**Planning Commission Regular Meeting**

Tuesday, August 18, 2026, 5:30 PM

The Mamba Trust Site  
Work Variance Request,  
219 Glen Eagle Loop

### **Planning Commission Staff Report**

Landscape Plan  
The Mamba Trust  
0219 Glen Eagle Loop, Breckenridge, Colorado  
Scale: 1" = 10'  
(Revised) July 17, 2026

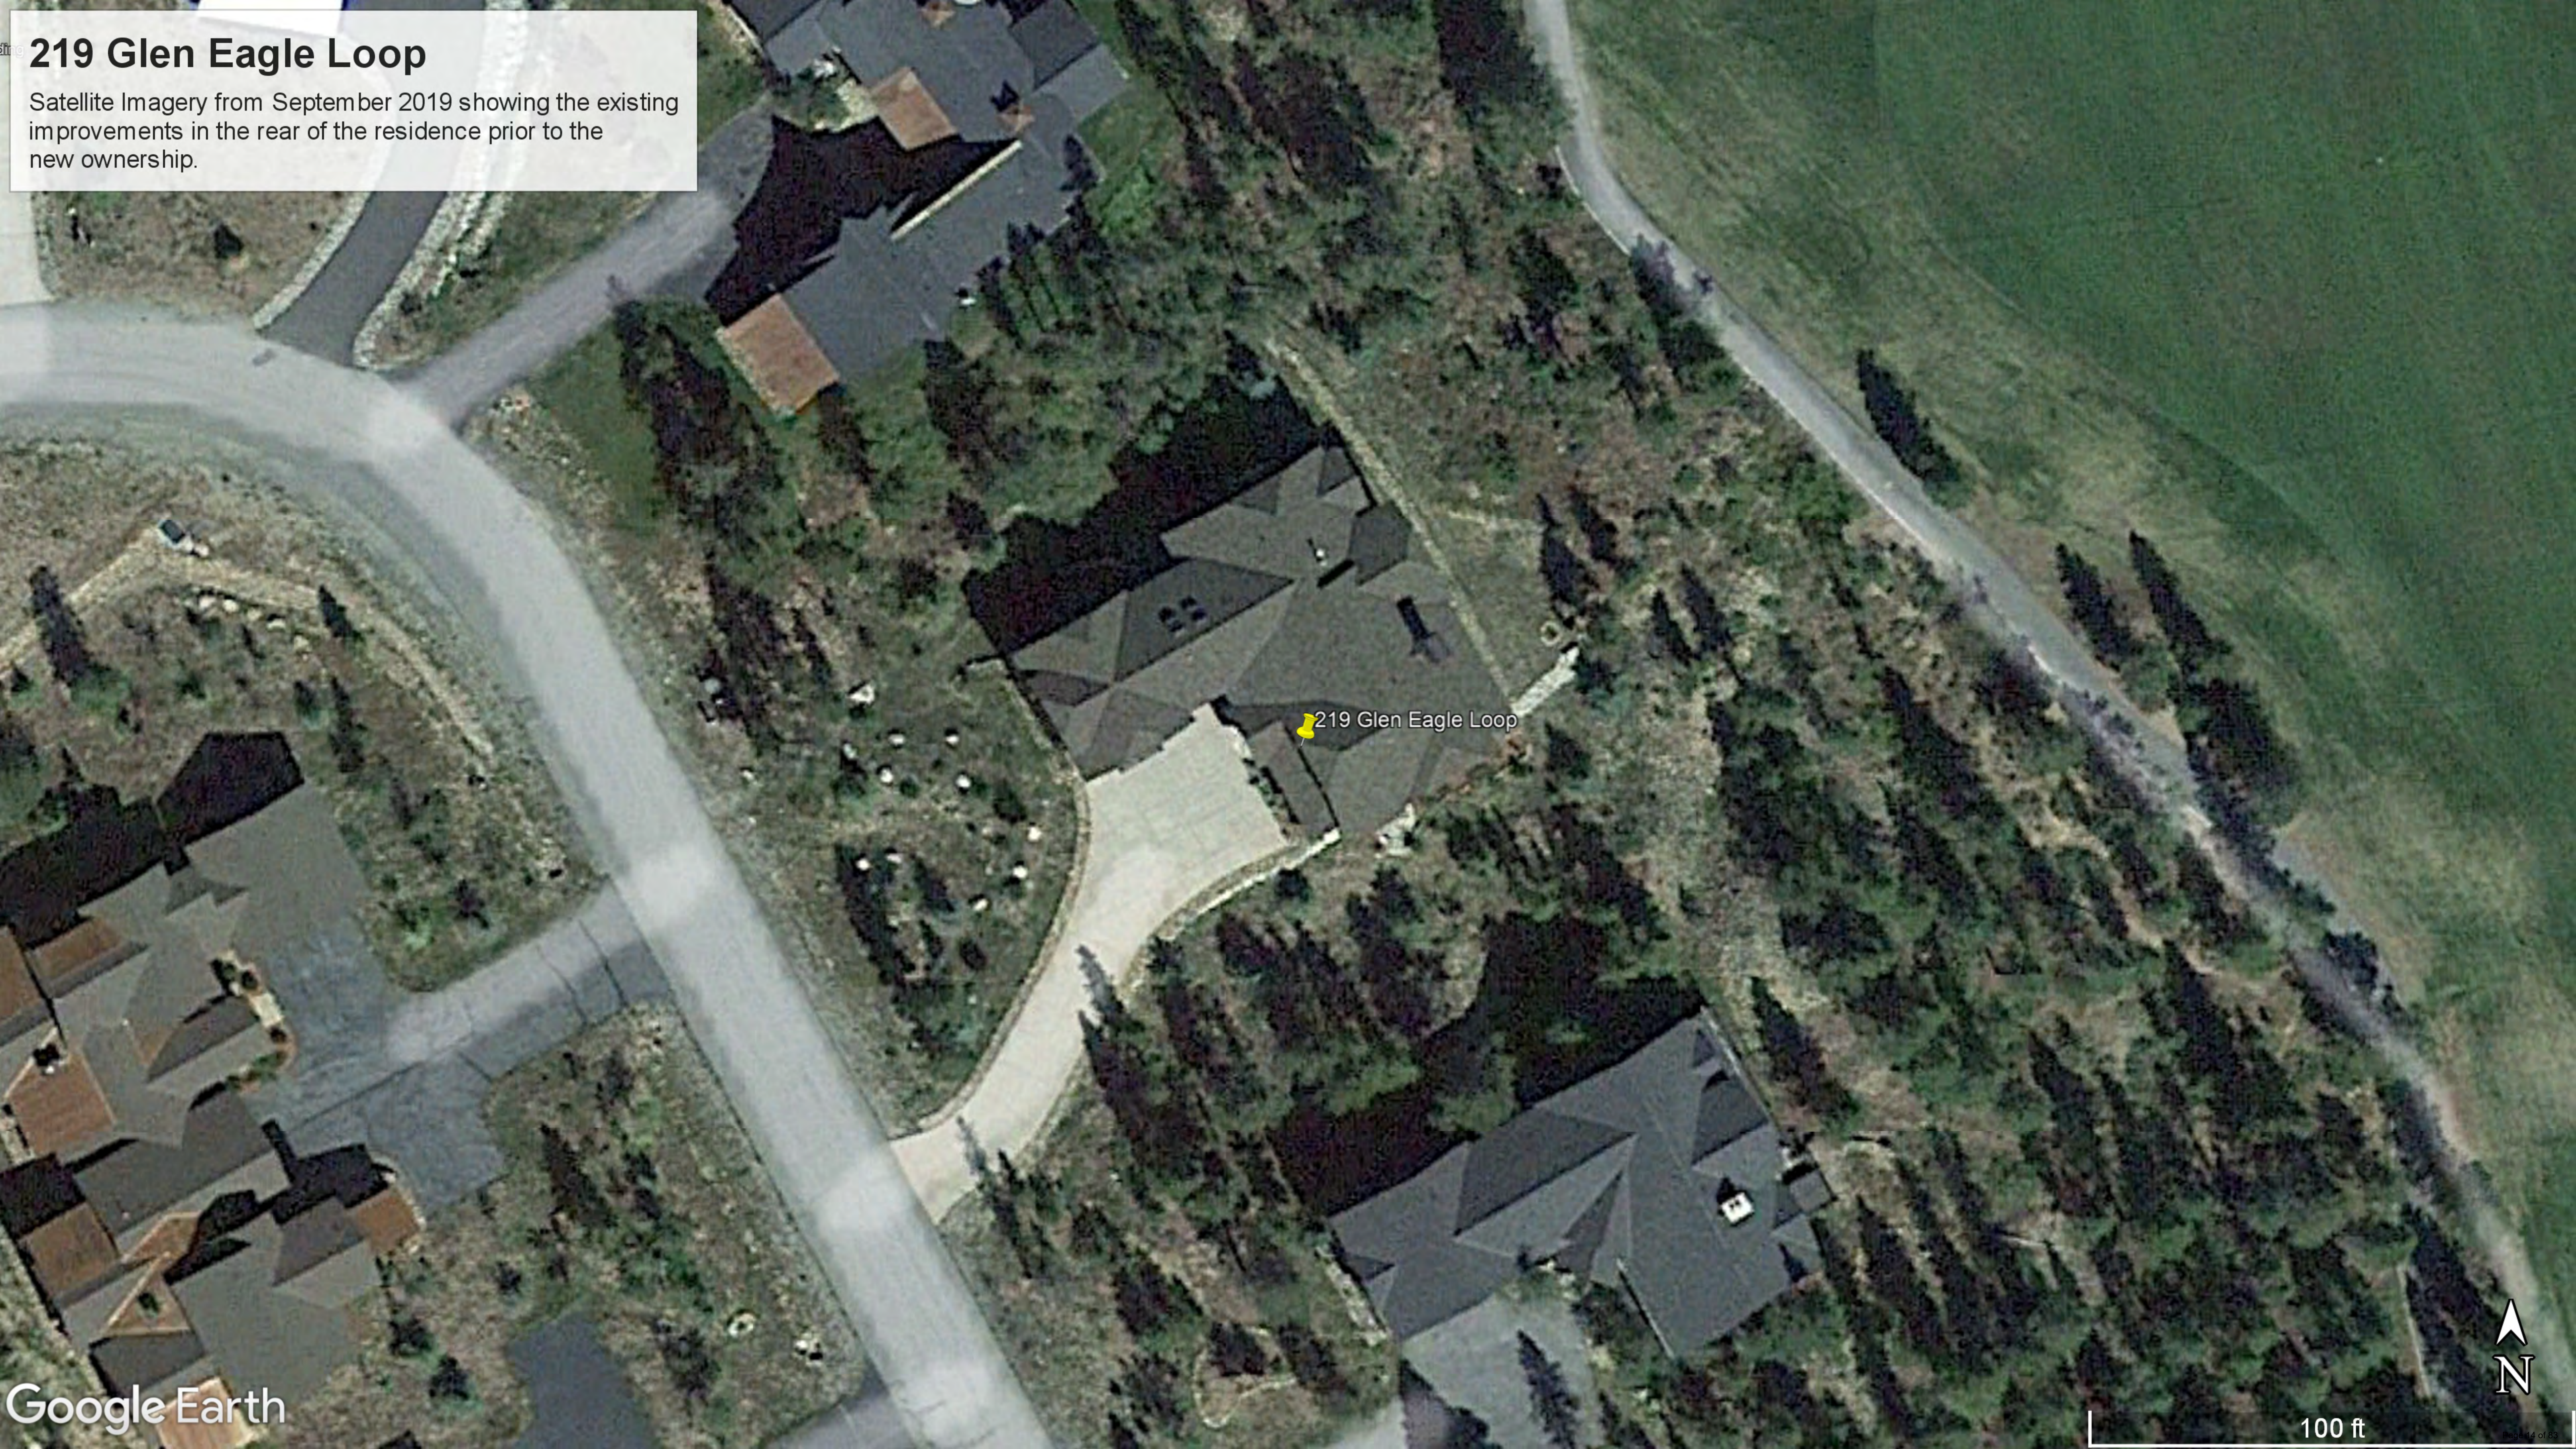
Staff believes the applicant does not meet Variance Criteria D.1. The record does not show that the strict application of the disturbance envelope substantially restricts the effectiveness of the existing residential development. The wall may support a preferred landscape condition or yard design, but staff does not find that it is necessary for the reasonable residential use of the lot.

Staff would note that the portion of the wall that could reasonably be considered to be a replacement for a preexisting retaining structure is not the portion of the wall that is the subject of the variance request. The photographs of the existing conditions prior to the commencement of unpermitted work show that the area in question sloped gently downward and did not appear to be in danger of collapsing, sliding, or otherwise in need of retention.

Staff does not find that the applicant has sufficiently evaluated a Code-compliant restoration plan, reduction of the wall to the disturbance envelope, removal of wall segments outside the envelope, or other stabilization and revegetation measures that would comply with the recorded plat restriction. Because the

In conclusion, staff recommends that the Planning Commission deny the requested variance from the Development Code to allow a portion of an existing, unpermitted retaining wall to remain beyond the platted disturbance envelope.

Other site improvements, including grading, drainage, turf, irrigation, patio, pathways, planting, and defensible-space items, remain under separate review through PL-2026-0092 or other applicable compliance/enforcement actions. If the variance is denied, the applicant will need to revise the related Class D Minor application to remove or modify the retaining/landscape wall that is the subject of this variance provide a compliant restoration, stabilization, and landscape plan.

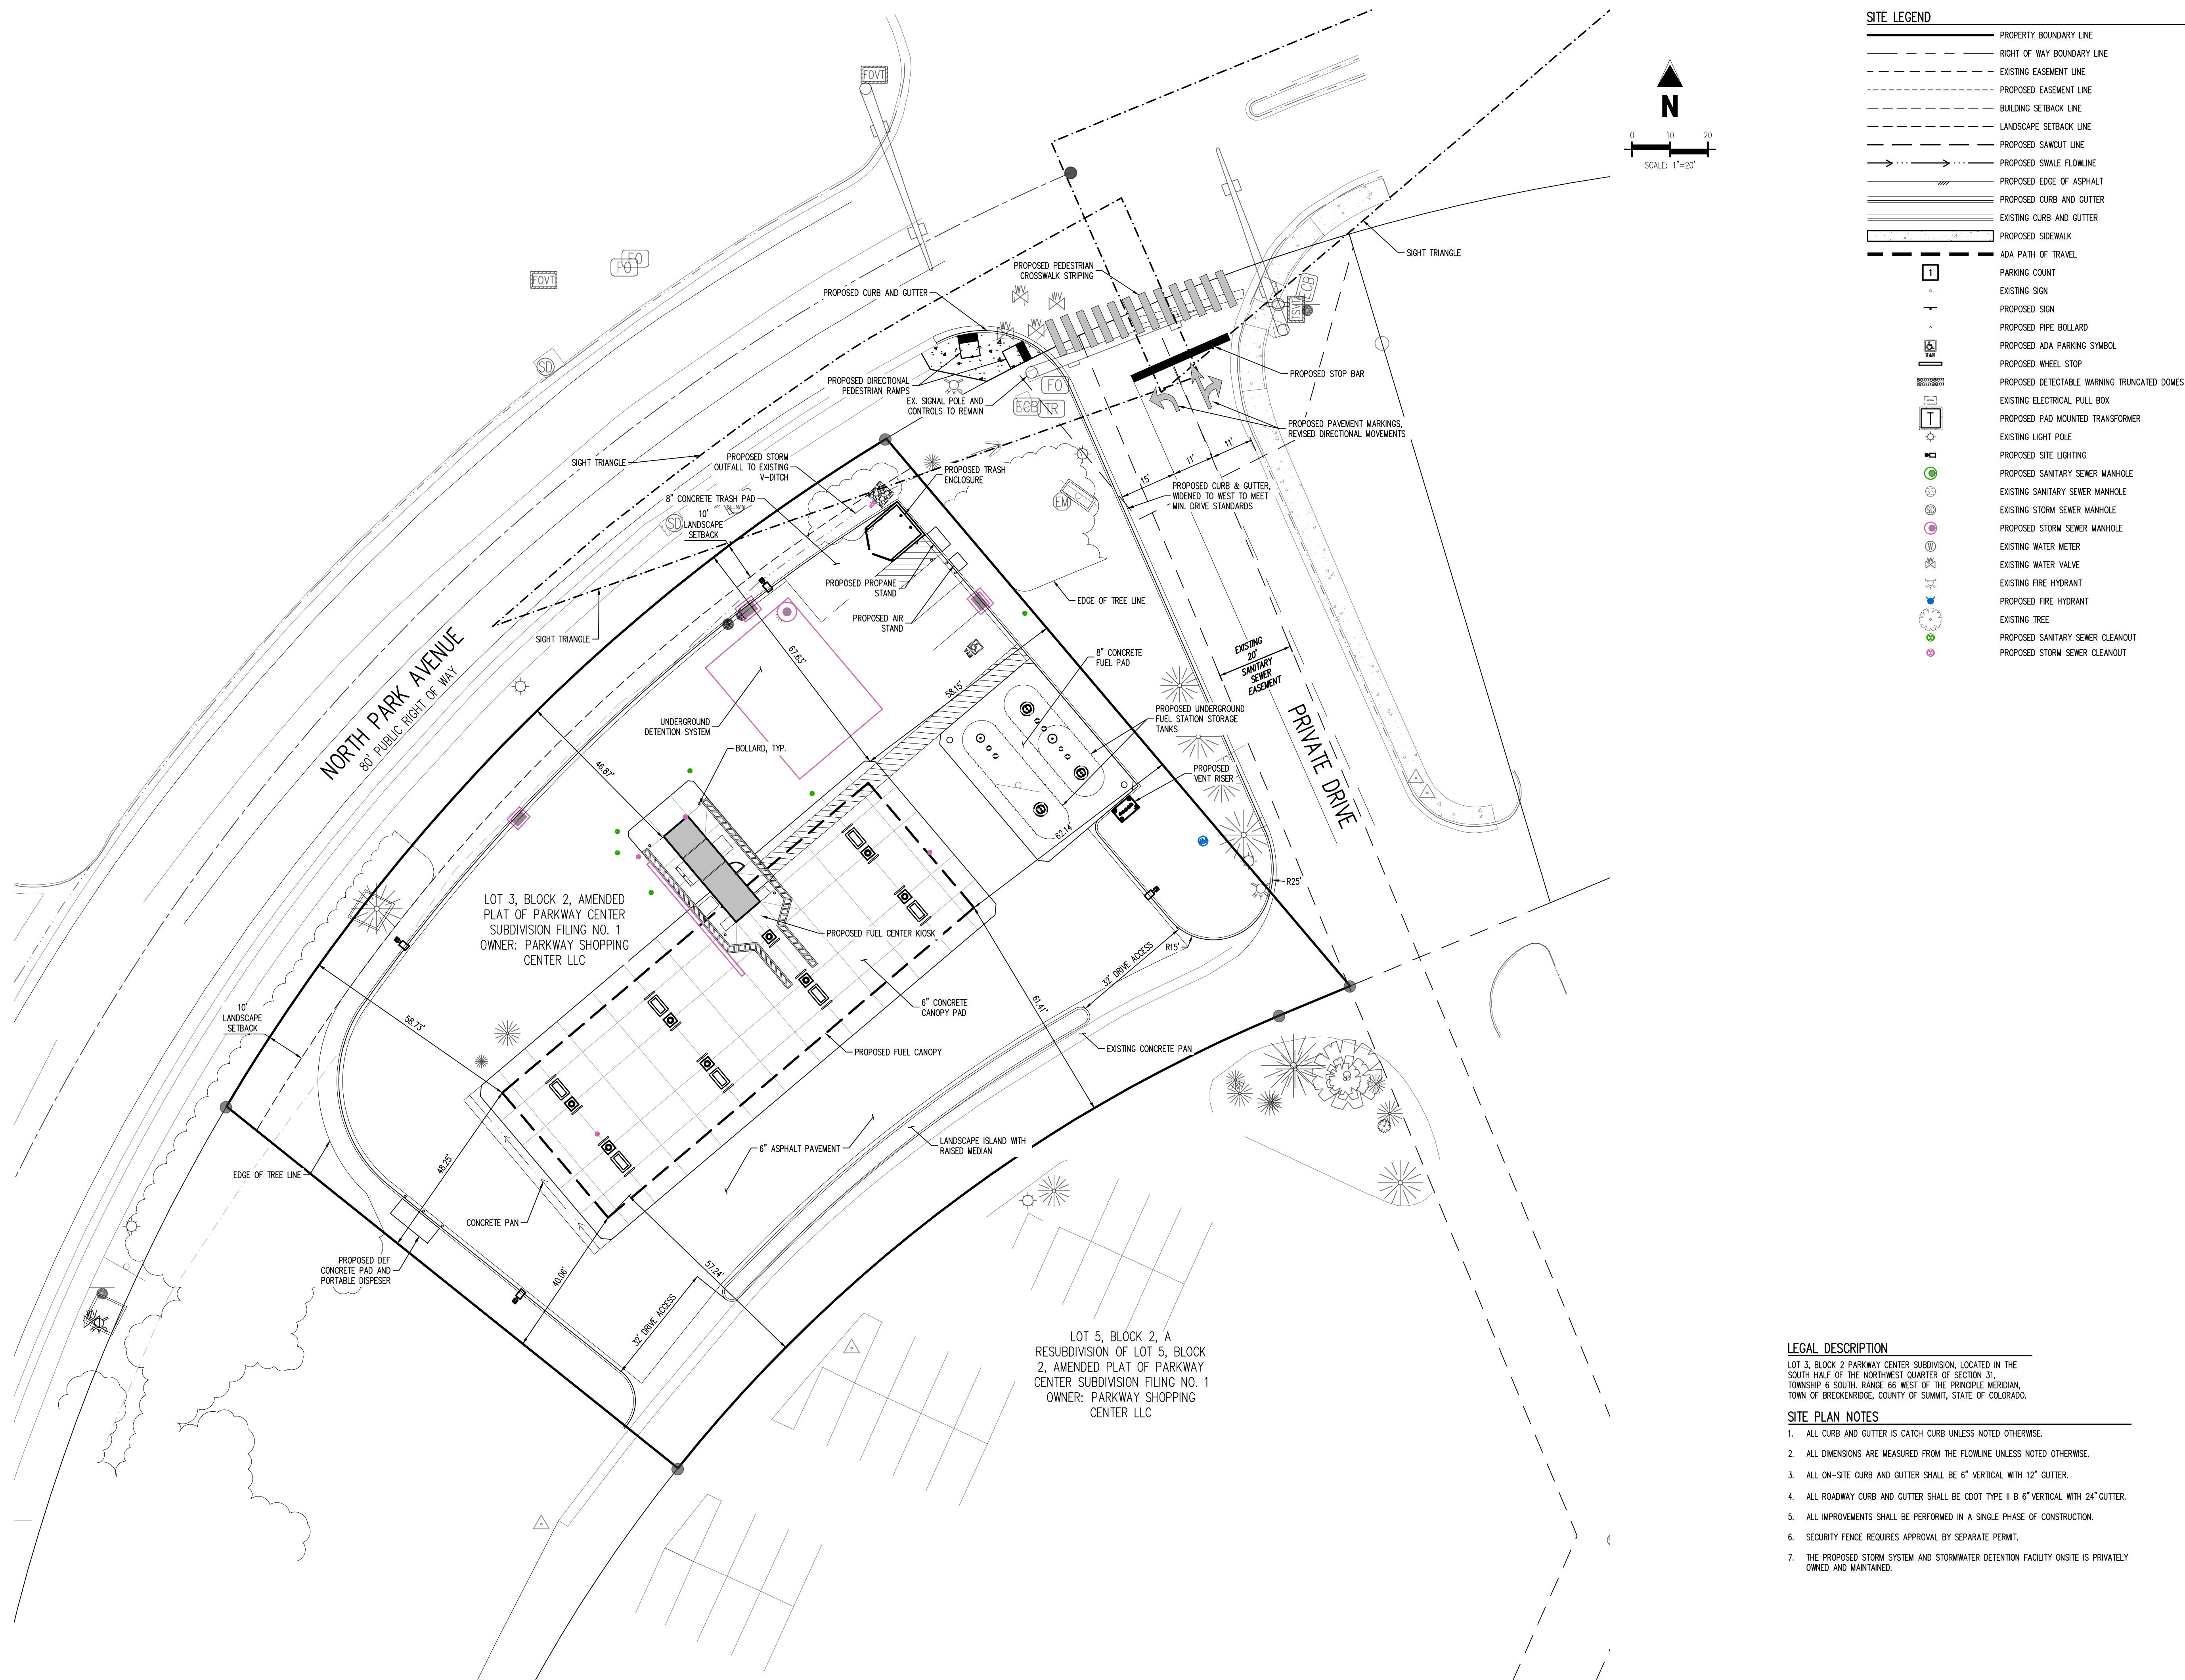
The third-party review and Staff's review raised several questions regarding the west driveway configuration which remain unresolved. Currently, the applicant does not agree with the Town and Kimley-Horn's interpretation of the Park Avenue/SH9 Access Management Plan which requires the conversion of the west driveway to a right-in/right-out access and continues to assume in the design and analysis that a full-movement driveway will remain. The applicant will need to address the west driveway configuration after CDOT's review of the revised TIS and access permit applications. Regardless of CDOT's final determination, the west driveway geometry including turning radii and lane widths must be

The applicant states in their TIS review response that the “subject site has been designed to allow for a future widening of SH-9 including two northbound through lanes on SH-9.” Staff request that updated project drawings explicitly illustrate how this condition will be achieved by showing future lane geometry, sidewalks, setbacks, and landscape buffering along Park Avenue meeting current Town and CDOT design standards prior to a final hearing.

An existing 5' sidewalk is located along the east side of the north driveway. No additional pedestrian or bicycle facilities are proposed or appear to be considered with the design; which may impact options for pedestrian connectivity to the forthcoming redevelopment of the adjacent Parkway Center parcels.
